MEMORANDUM

SUBJECT: Region 6 Responses to the National Remedy Review Board (NRRB) Recommendations for the San Jacinto Waste Pits Superfund Site, Harris County, Texas

FROM: Carl E. Edlund, Director
Superfund Division (6SF)

TO: Douglas C. Ammon, Chair
National Remedy Review Board (OSRTI)

Figure 3-4
Spatial Distribution of Predicted Net Sedimentation Rate for
21-Year Period: Pre-TCRA Base Case Simulation
Feasibility Study
San Jacinto River Waste Pits Superfund Site

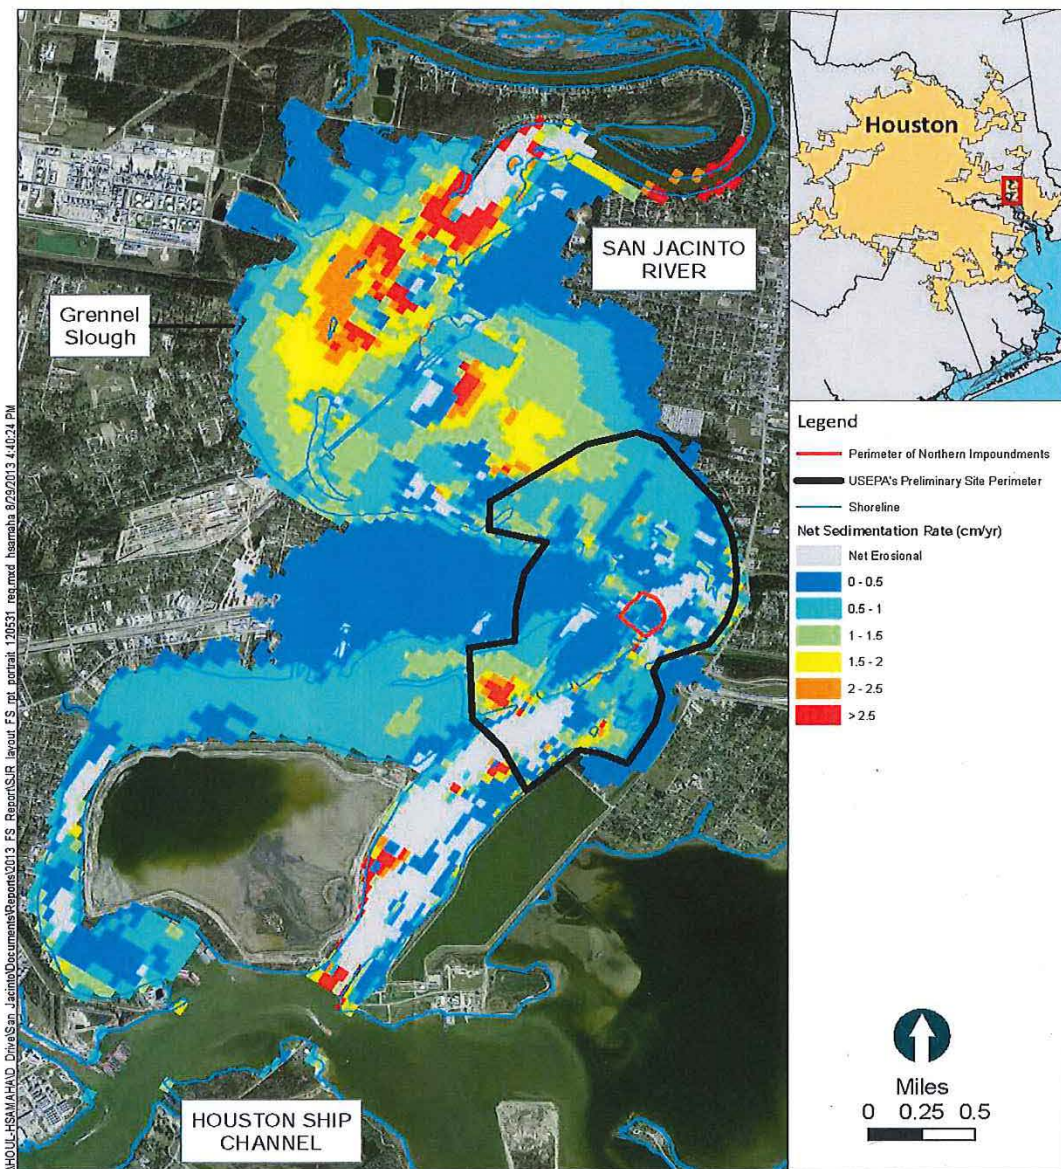
In the package presented to the Board, monitored natural recovery (MNR) is being considered to address contamination in the aquatic environment north of Interstate-10. However, the package did not include an evaluation of MNR's efficacy relative to reaching the relevant RAOs. Given the effects of storms on sediments, it is unclear whether MNR (e.g., by facilitating a covering of cleaner sediments) can be relied upon as a remedial component. The Board recommends that the Region include in the decision documents information on where MNR may be used and an evaluation as to how aquatic conditions (deposition, erosion) in those areas will affect the remedy's protectiveness and future permanence.

Spatial distributions of predicted net sedimentation rates (NSRs) for the long-term simulation period for pre- (i.e., the sediment transport model calibration) and post-TCRA conditions as shown on Figures 3-4 and 3-5 (Appendix A of the FS), respectively are shown below.
